PROJECT NUMBER: 1006802  
APPLICATION NUMBER: 08DRB-7036

**SITEPLAN**

PROJECT TITLE: PASO DEL NORTE & VENTURA  
PROJECT MANAGER: PASO DEL NORTE AND VENTURA ALBUQUERQUE, NM  
DRAWN BY: JCS  
JOB NO.:  
SHEET TITLE: SITE PLAN FOR BUILDING PERMIT

DATE: 6.22.07  
SCALE: AS NOTED  
sheet: AS2

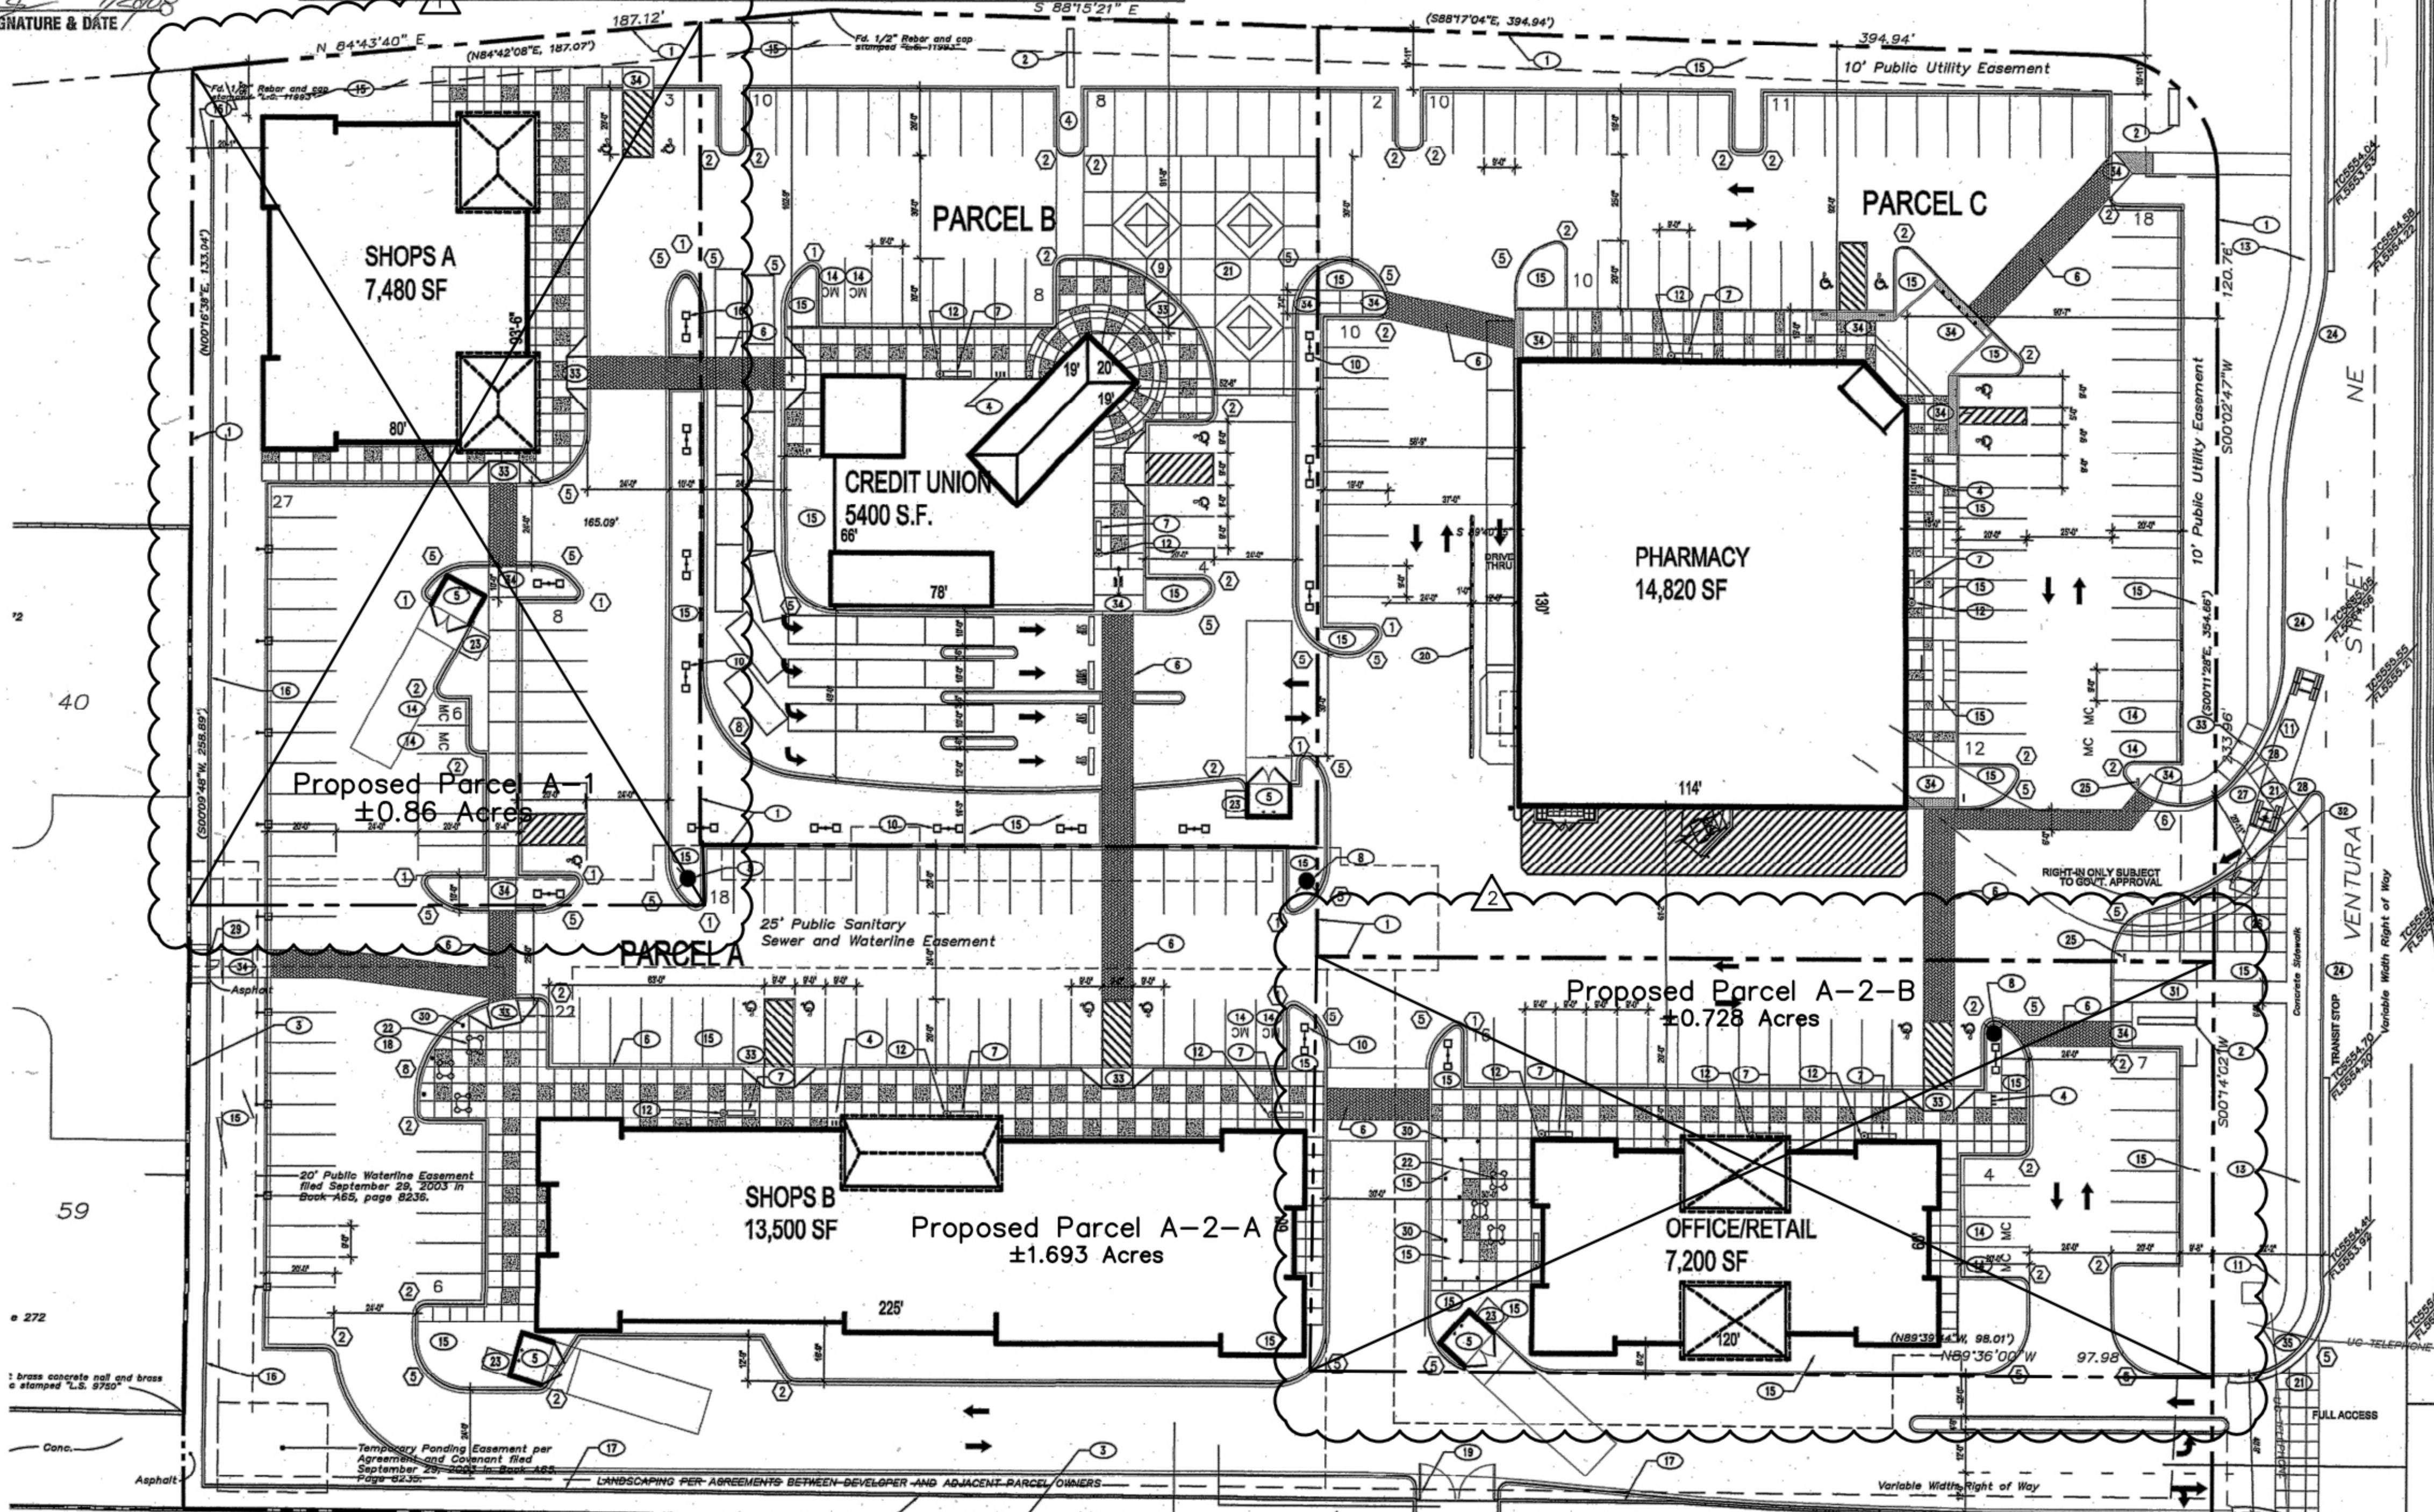
1 4/25/2017; SUBDIVIDE PARCEL A INTO PARCEL A-1 AND A-2. REVISE SITE PLAN TO REMOVE 7,480 SF SHOPS 'A' BUILDING AND REPLACE WITH NEW +/-4,896 SF GENERAL AUTOMOTIVE REPAIR W/ 9 BAYS. REF. SHEET AS5 FOR THE REVISED SITE PLAN FOR BUILDING PERMIT.

2 8/31/2017; SUBDIVIDE PARCEL A-2 INTO PARCEL A-2-A AND A-2-B. REVISE SITE PLAN TO REMOVE 7,200 SF OFFICE/RETAIL BUILDING AND REPLACE WITH NEW +/-7,300 SF AUTO PARTS STORE-REF. SHEET AS6 FOR THE REVISED SITE PLAN FOR BUILDING PERMIT.
